RE: Western Geo-Engineers response to the Glenview Neighborhood Associations letter dated November 6, 2009, Former Desert Petroleum Site DP793 dated March 19, 2010.

Response to November 6, 2009 Glenview Neighborhood Association request for clarification, i.e. items 1 through 9 as directed by Alameda County Health Care Services correspondence March 2, 2010.

Subject: Fuel Leak Case No. RO0000429 and Geotracker Global ID T0600100158, Desert Petroleum Site DP793, 4035 Park Boulevard, Oakland, CA 94602 – Comments from Glenview Neighborhood Association

re:Fuel Leak Case No RO0000429, Desert Petroleum Site DP793,
4035 Park Boulevard, Oakland, CA 94602 –
Glenview Neighborhood Association Concerns Regarding Proposed Remediation

FIGURE 1
DP793, 4035 PARK BLVD.
OAKLAND, CALIFORNIA
 PROPOSED EXCAVATION AND CONNECTION LATERAL TREATMENT COMPOUND TO RECEPTOR TRENCH

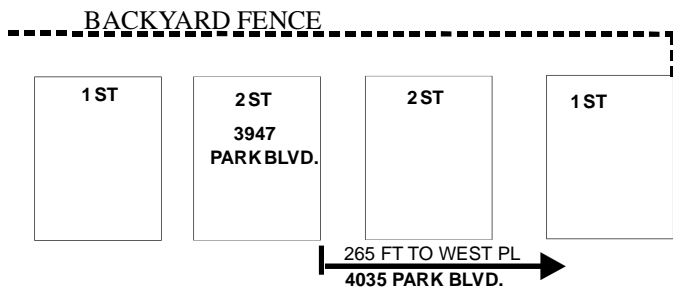
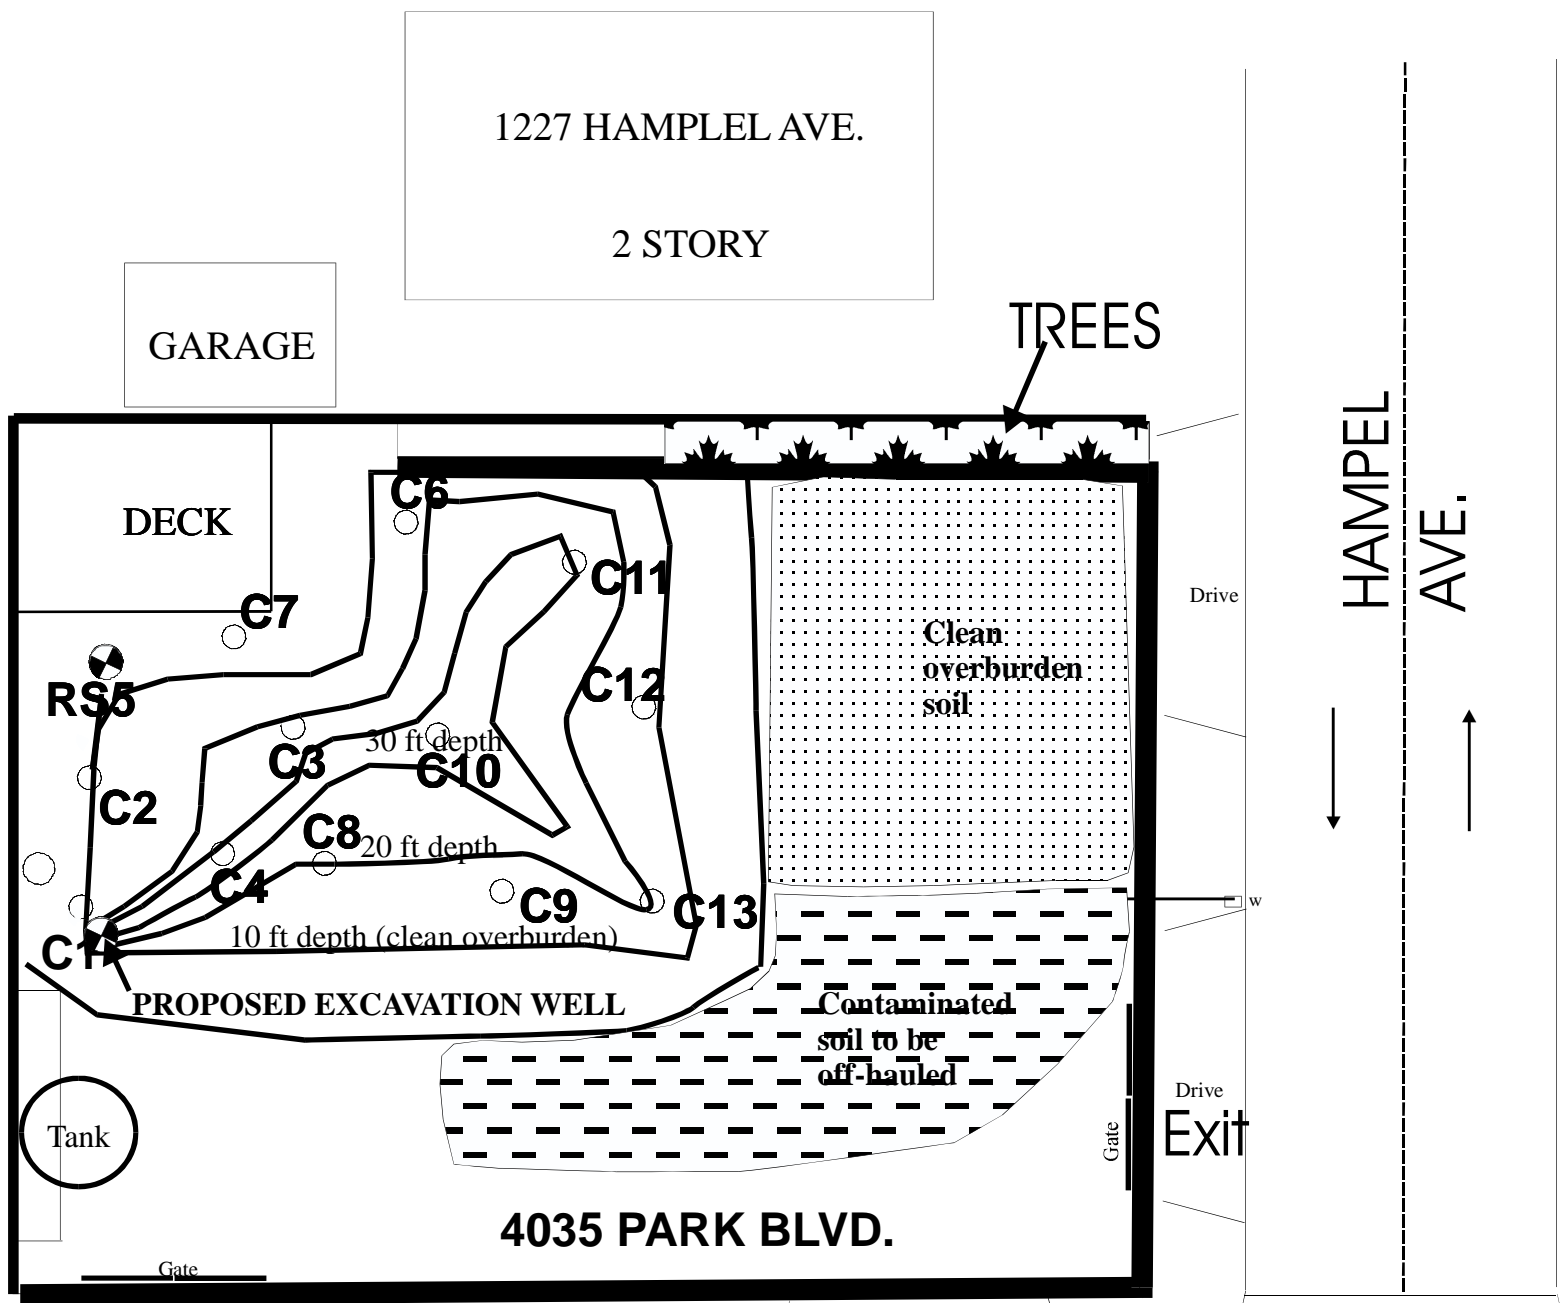
4. Impact on neighboring community uses: There is a daycare center on Park 3 to 4 houses below on Brighton – does the RP's air monitoring plan take this into account? Will the bus stop and casual carpool locations be affected by the work? How will they protect health and safety of users of those locations?

The excavation, stockpiling and off hauling of contaminated soils will not impact the day care center. It is located upwind and 265 feet west of the site. The predominate wind direction is from the San Francisco Bay, which is northwest of the site. The wind direction encountered at the site is influenced by the normal easterly wind direction along with the channeling from the topographic low and buildings west and north of the site, producing an east southeast wind direction, towards the intersection of Hampel Street and Park Blvd., see Figure 1. Wind direction indicators will be placed along the perimeter of the site and visually monitored.

FIGURE 2

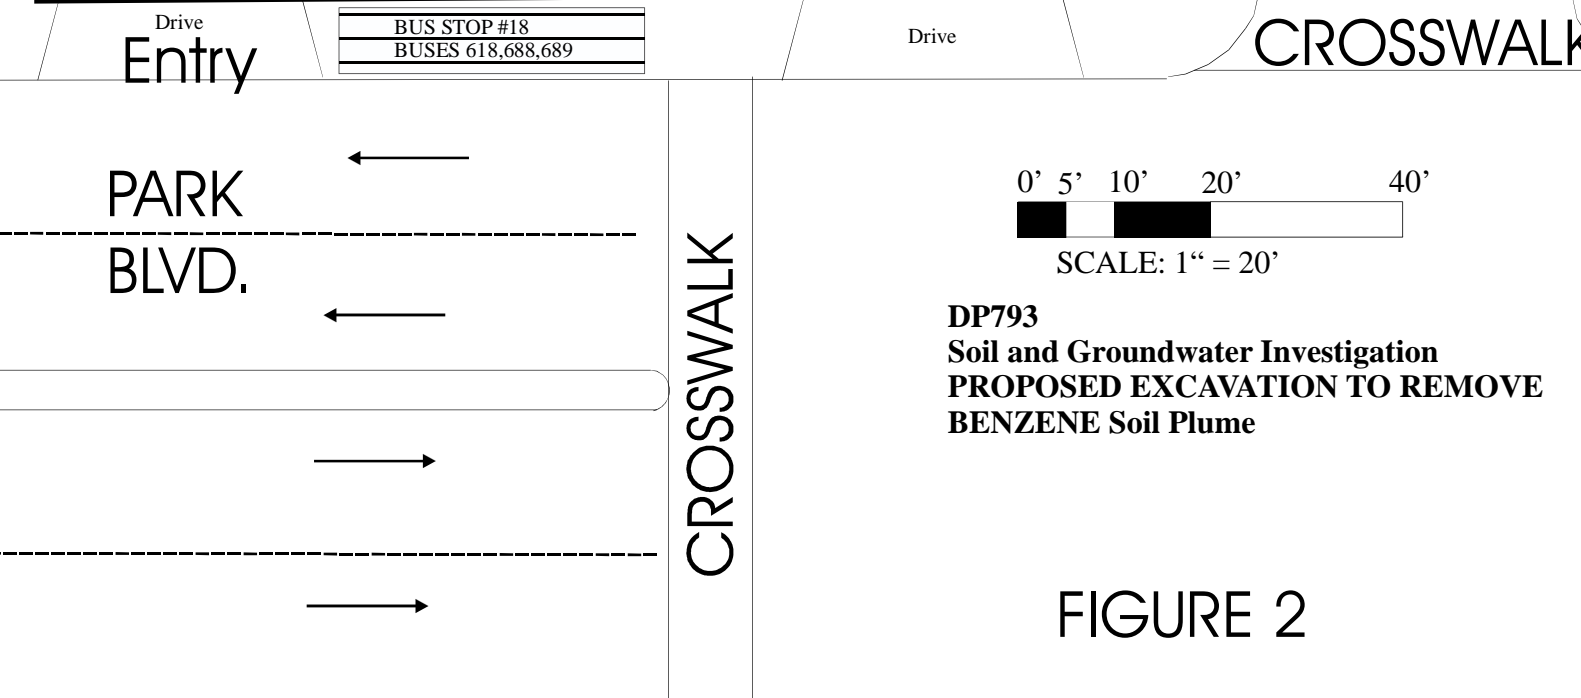
5. Stockpiles: How high and large will the stockpiles be? The RPs appear to be planning to create two or three stockpiles: one with 800 cubic yards of soil and two others with a combined total of approximately 900 cubic yards of soil. Where are they planning to put that much soil? How will stockpile covers be maintained? Is there a maximum stockpile height and slope that is allowed?

For safety considerations the casual carpool location cannot be used during the duration of this project. A gate will be placed at the drive along Hampel Avenue closest to Park Blvd., see Figure 2. This drive will allow the trucks to safely exit the site as needed, drivers attempting to park cars in this drive during work activities will be asked to relocate. If the car is not attended and the owner cannot be located, the car will be towed at the owners' expense. Prior to starting the excavation work signs will be posted along the Hampel Street side of the site notifying that no parking will be permitted in the gated drives of the site.

There will be two access points to the fenced site, the drive west of bus stop #18 and the drive at Hampel Street, immediately north of the intersection with Park Blvd., see Figure 2. When vehicles are entering or leaving the site, flagmen will be designated to alert both pedestrian and vehicle traffic. Air monitoring for both dust and volatile organics will be ongoing during the operations, see Item 3. The sidewalk and drive areas will be kept clean of excavated soils to eliminate any slip/trip hazards caused by the excavation/backfilling activities of the site. Only authorized personnel will be allowed to enter the fenced in site, no exceptions will be made. Site work will be conducted between 8:00 AM and 5:00 PM weekdays. At the completion of every work day, the site will be secured (all excavated soil piles will be covered), inspection of, and if necessary repair of all sediment control devices will be accomplished. The excavation will contain an easy ingress/regress area (ramp) and the fence gates will be locked. See Item 3 - Air monitoring.

Contaminated soils will be stockpile directly south of the clean overburden soil and will be removed as quickly as profiling allows. When this stockpile is inactive (not being added to or being removed) it will be covered with a plastic liner, see Figure 2. Previous sample results (from borings and soil cores) indicated that the highest contaminate levels are found in soils between the 12 foot and 24 foot depths.

Figure 3

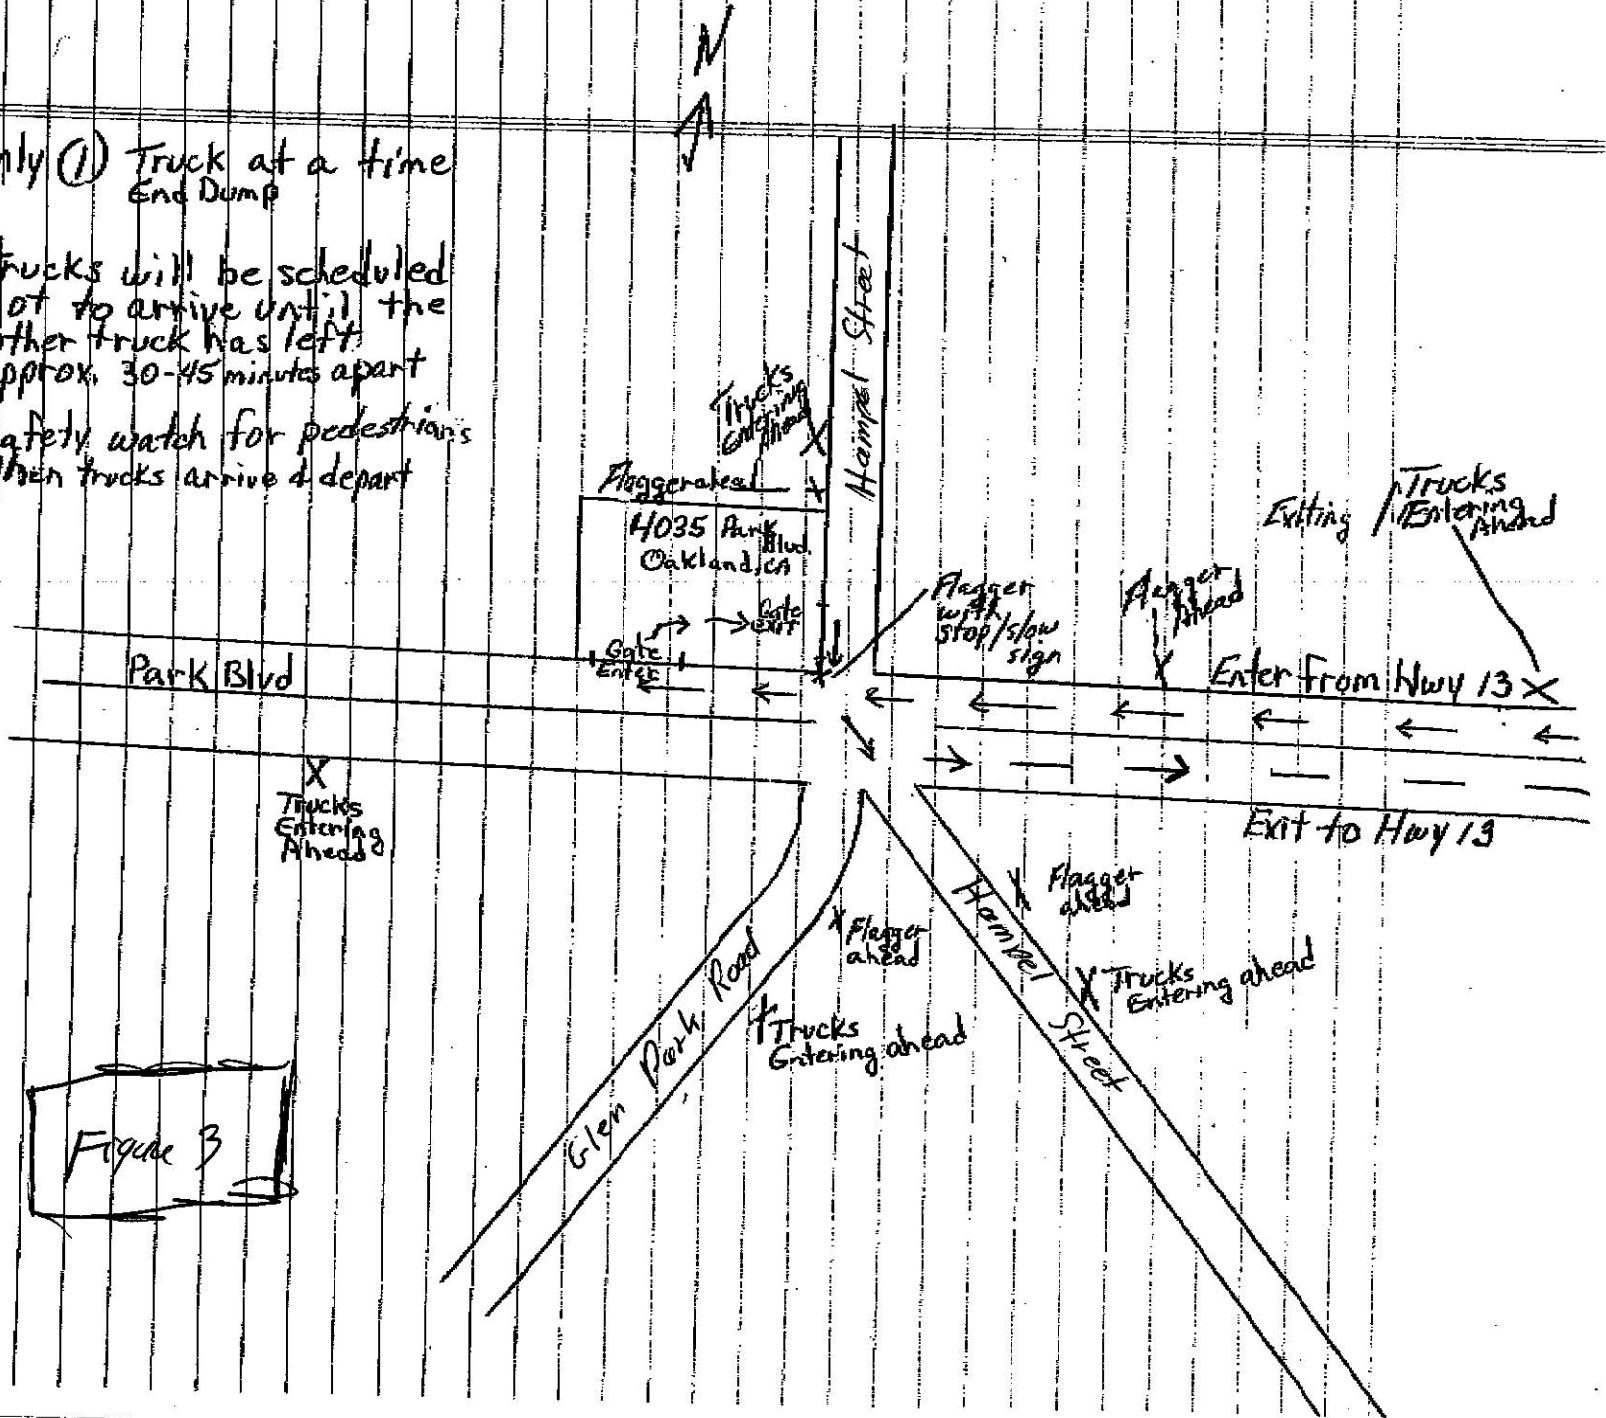
7. Traffic Control: If the RPs are planning to off haul soil, how do they plan to access the site with trucks, what will be the traffic control requirements, where will waiting trucks be parked, and how long will they be allowed to idle? Will flagging and flagmen be required when they are loading and transporting soil? What route will the trucks travel? Will they load from Hampel or Park? If from Hampel, how will they get the trucks into position (Brighton and Edgewood are small streets, not suitable for end dumps, Park Blvd is a major thoroughfare). Where will the trucks go after they leave the site (580 doesn't allow trucks until Grand Ave). If they are going to turn around and go up to 13, where will they do that? How will the contractor keep soil off the roads when they are hauling away? In other words, is there a traffic control plan and a dust control plan, and, if so, who will be responsible for seeing that they are implemented?

See Site Figure 2 and 3. The equipment trucks, vehicles and end dumps will enter the site at the present gate located on Park Blvd. Vehicles will leave the site from, a "to be installed gate" located at the southeast corner of the site on Hampel Street. The trucks, end dumps etc. will turn east onto Park Blvd to exit the site. When equipment, end dumps etc., are leaving the site flagmen will be situated to alert oncoming traffic, see Figure 3 for signage and truck route near site.

Trucks used to off-haul contaminated soil will enter the site from west bound Park Blvd. and enter the site at the Park Blvd gated entrance. Once the truck is loaded, the load will be covered to prevent dust. Signage alerting traffic along Park Blvd., Hampel Street and Glen Park Road will be posted, see Figure 3.

Only ① Truck at a time
End Dump

Trucks will be scheduled
not to arrive until the
other truck has left
approx. 30-45 minutes apart

Safety watch for pedestrians
when trucks arrive & depart
